AIRWORTHINESS DIRECTIVE

- SUBJECT:** Possible incorrect assembly of the aileron drive mechanism.
- TYPE AFFECTED:** Jantar 2A and Jantar 2B
- BACKGROUND:** When the glider is de-rigged it is possible for the aileron to become dislodged from its hinges. When re-installing the ailerons it is possible to install the aileron drive incorrectly by inserting the lever end above the guide instead of into it. Incorrect assembly can only be detected by the change in aileron deflection and operating noise of the aileron. Stick travel is not restricted by incorrect assembly of the aileron.

Ref: Inspection of the correct installation of aileron control system levers in the wing guides.

Fig. 1

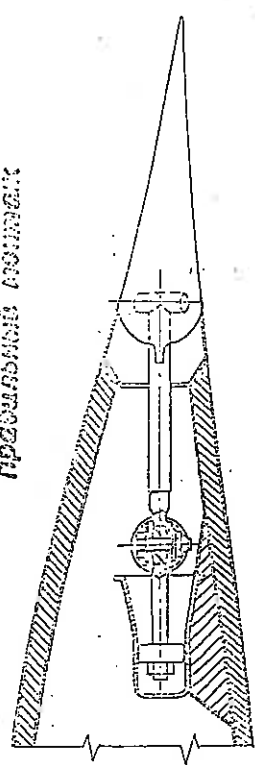
The sketches Fig. 1 and Fig. 2 show the correctly and incorrectly assembled aileron control levers.

montaż prawidłowy
correct assembling
richtige Zusammenbauung
правильный монтаж

5.1. When assembling the inner aileron pay a special attention to insert correctly the ends of control levers into the "pockets" of the guide housing.
After assembling check the aileron deflections to be correct.

Fig. 2

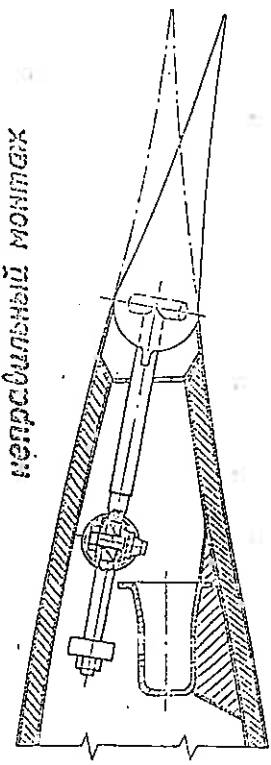
In the operation the case of incorrect assembling of aileron control system occurred. It depended on the fact that the lever end has been inserted above the guide housing instead of to be inserted into the "pocket" formed by the guide housing.
